SALINE RIVER
BRIDGE

REFERENCE MILE 521 MACKENZIE HIGHWAY

**BASIC ENVIRONMENTAL DATA
SALINE RIVER BRIDGE
REFERENCE MILE 521**

**DEPARTMENT OF PUBLIC WORKS
EDMONTON, CANADA**

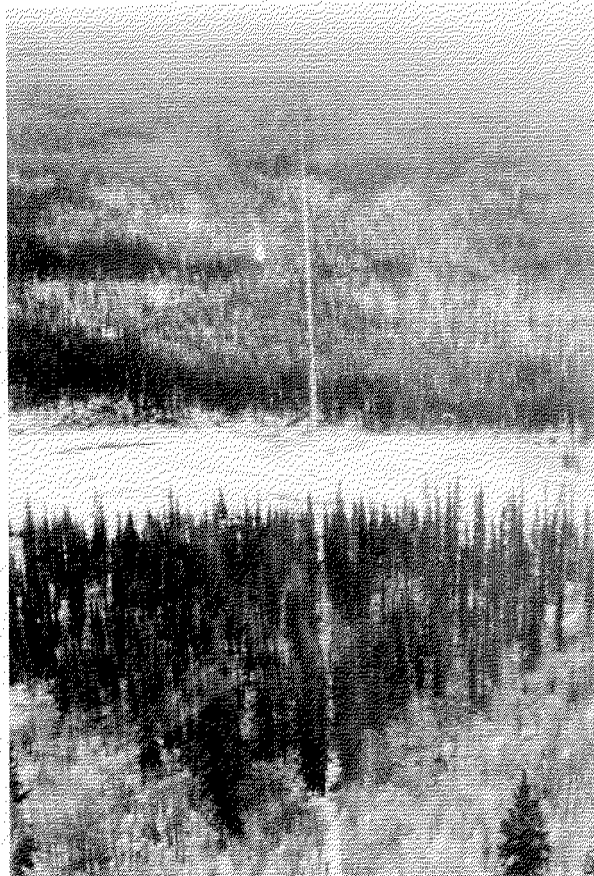
Increased stream velocities are the primary concern at this site and calculations of water velocities at peak flows should be made to ensure that velocity barriers to fish would not develop.

29.10.72. Saline River looking south at bridge site. Footings of proposed bridge in active channel; fill may restrict channel; high erosion hazard potential.

26.10.72. Saline River looking southerly. CNT landline shown in upper left corner. Winter road in foreground. Both banks are steep, south bank composed of glaciolfluvial silt and clay with possible old slump material; north side is in same material but banks appear well drained and stable. Crossing will have low to moderate impact on fish. Drainage and subsequent erosion has developed along road in foreground. Adequate measures to accommodate this have not been accounted for in bridge design.
